PREVOST

**SAFETY
RECALL**

SR23-310

DATE :	August 2023	SECTION :	18 BODY
SUBJECT:	FLIP-UP SEAT PIVOT BOLTS

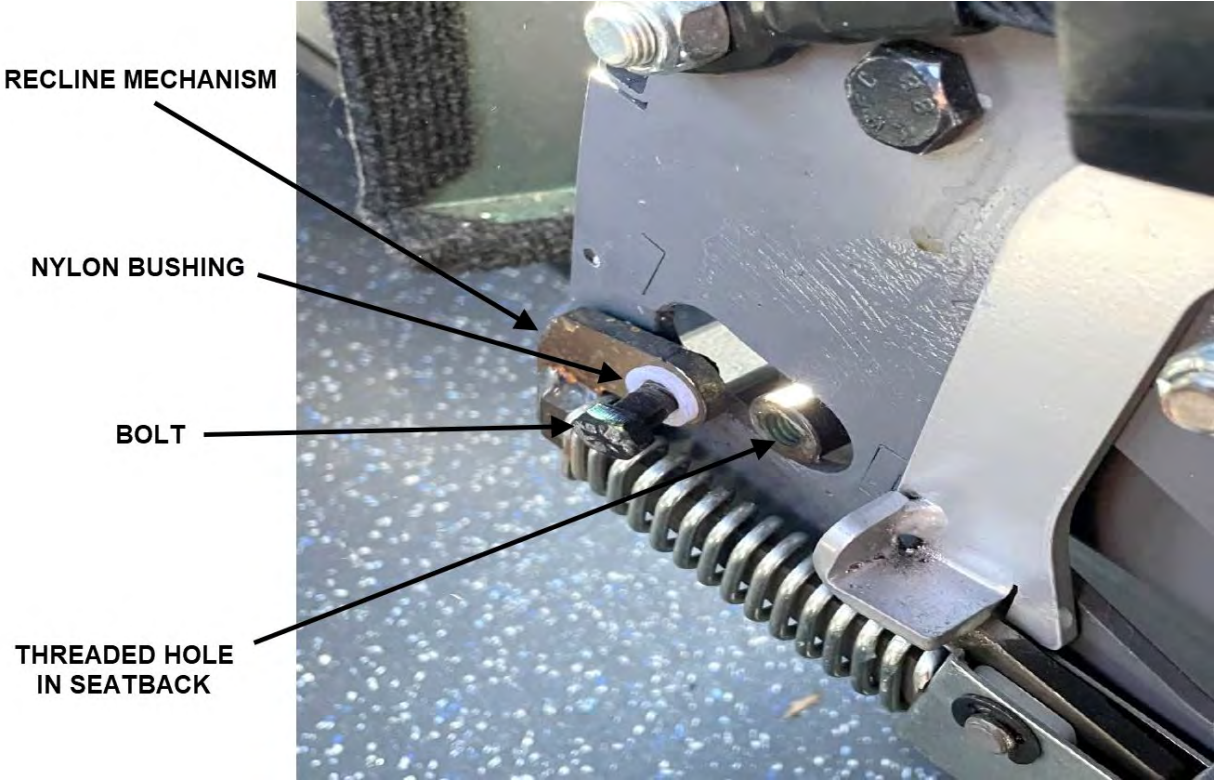
the bolt securing the passenger seat recline mechanism could loosen and disengage. In this condition, the seat's reclining function is inoperative (inability to lock the seatback in the desired angle), and the seatback can move freely within its adjusting limits. It is to be noted that the concerned seats are equipped with occupant seat belts integrated in the seat back.

Therefore on the affected vehicles, thread locker must be added and the seat recline mechanism bolts must be adequately torqued.

Bolts on both sides are covered by trim panels
